### **THREE KINGS RENEWAL, ADDENDUM TO STORMWATER MANAGEMENT PLAN, OPTION 15H1**

This letter forms an addendum to the Three Kings Renewal Stormwater Management Plan produced by Pattle Delamore Partners in September 2014. The addendum addresses questions identified by Auckland Council in their correspondence to Fletcher Residential Ltd of 26<sup>th</sup> August 2014 and 24<sup>th</sup> September 2014. The points addressed by PDP are items 48, 51, 54 relating to correspondence on 26<sup>th</sup> August and items 5.4, 8.1, 8.2, 8.5, 8.6, 8.13 relating to correspondence on 24<sup>th</sup> September 2014.

**Figure 1: Soakage Trench**

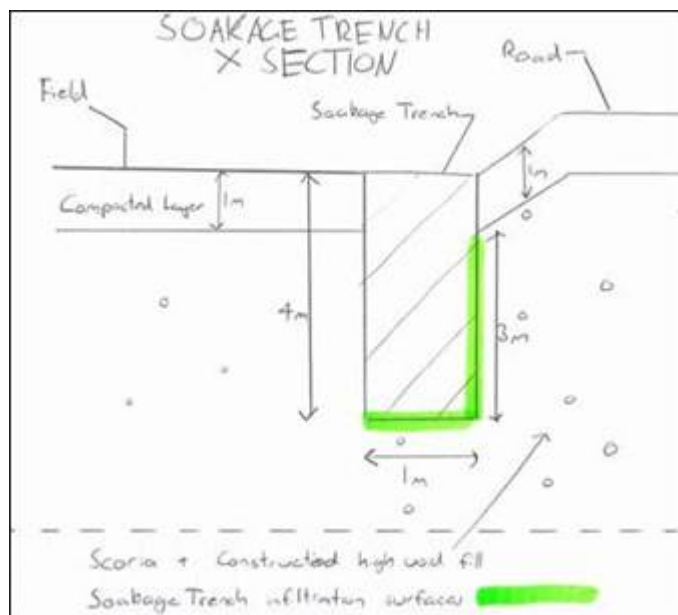
*Please provide further information on the expected flooding frequency/duration of the proposed sportsfields and the likely impact on use of the fields (i.e. field closures, additional maintenance and field repair following storm events).*

This is an assessment of the time taken to fully discharge stored stormwater from the fields to ground at the proposed Three Kings Renewal development for a range of rainfall events and soakage rates. This requires a conceptual design of the soakage method to the local and wider ground conditions.

Ultimate stormwater disposal from the sportsfields has been assumed to occur via soakage trenches excavated into the scoria at the south side of the field areas (as shown in Figure 1 below). For this conceptual design, five soakage trenches of length 50m each have been used (for a total of 250m of actual trench). Infiltration has been assumed to occur only through one wall towards the perimeter of the site and through the base of the soakage trenches (green on Figure 1).
